Amendments to the Drawings

Application Serial Nbr 09/692,990
Replacement Sheet

FIG. 4B

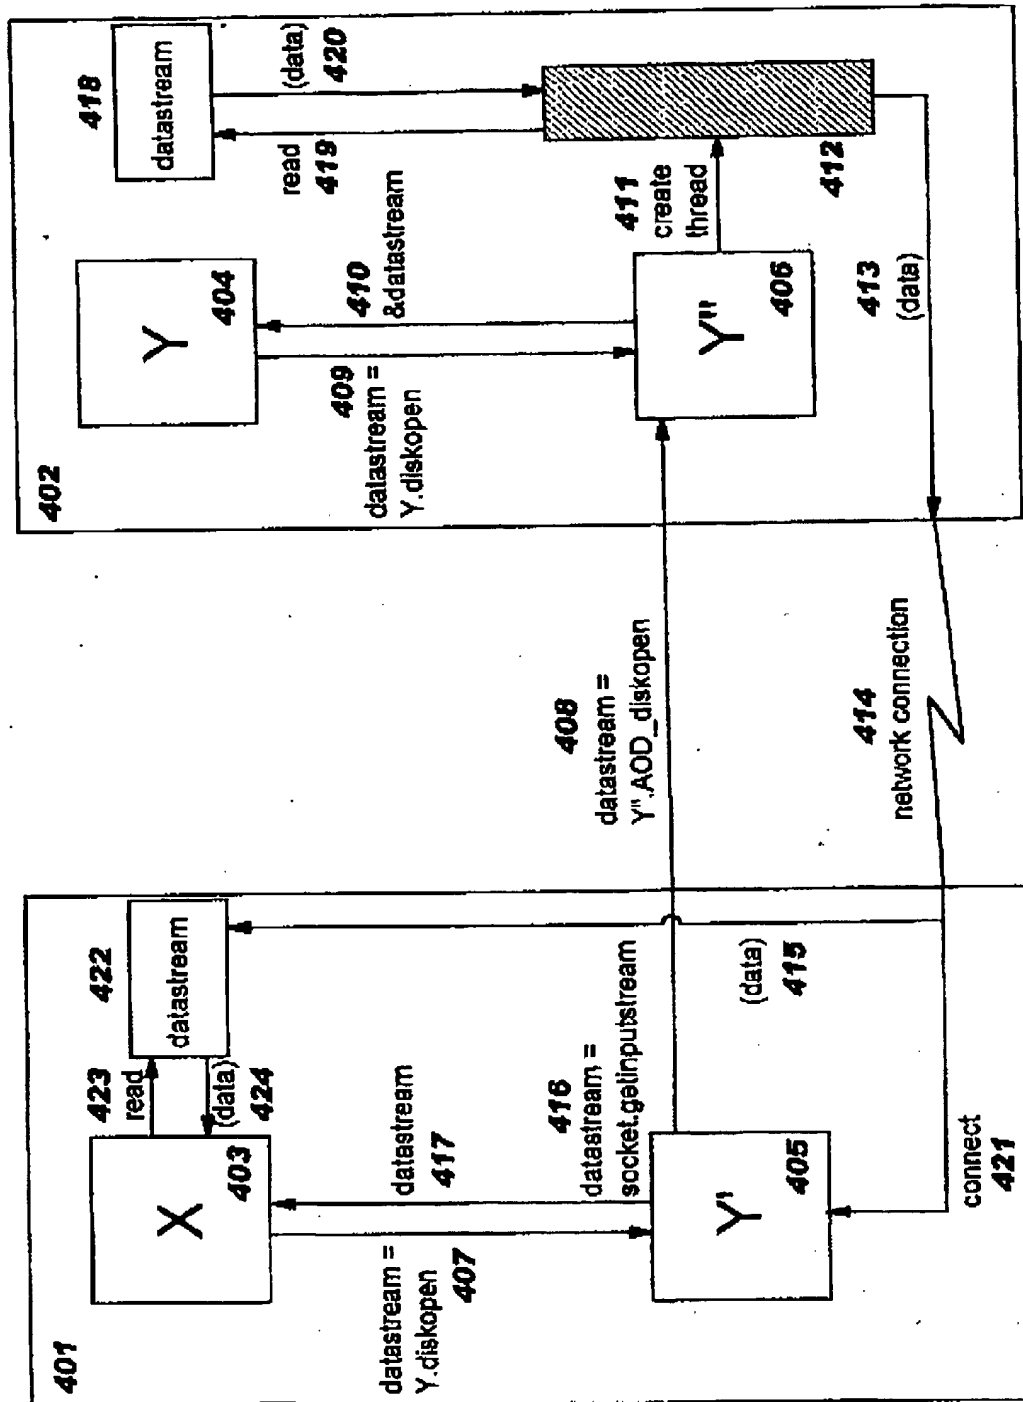
A proposed correction to **Figure 4B** adds an ampersand symbol for element **410**, such that it now reads "&datastream". This is supported in the specification on page 14, line 21 - page 15, line 1, which states that the result **410** is passed "in the form of a reference to a datastream object"; the ampersand symbol is well known to indicate an object reference. (See also page 9, lines 20 - 21, discussing a similar data stream object reference **417**, which is shown in **Figure 4A** as including an ampersand.)
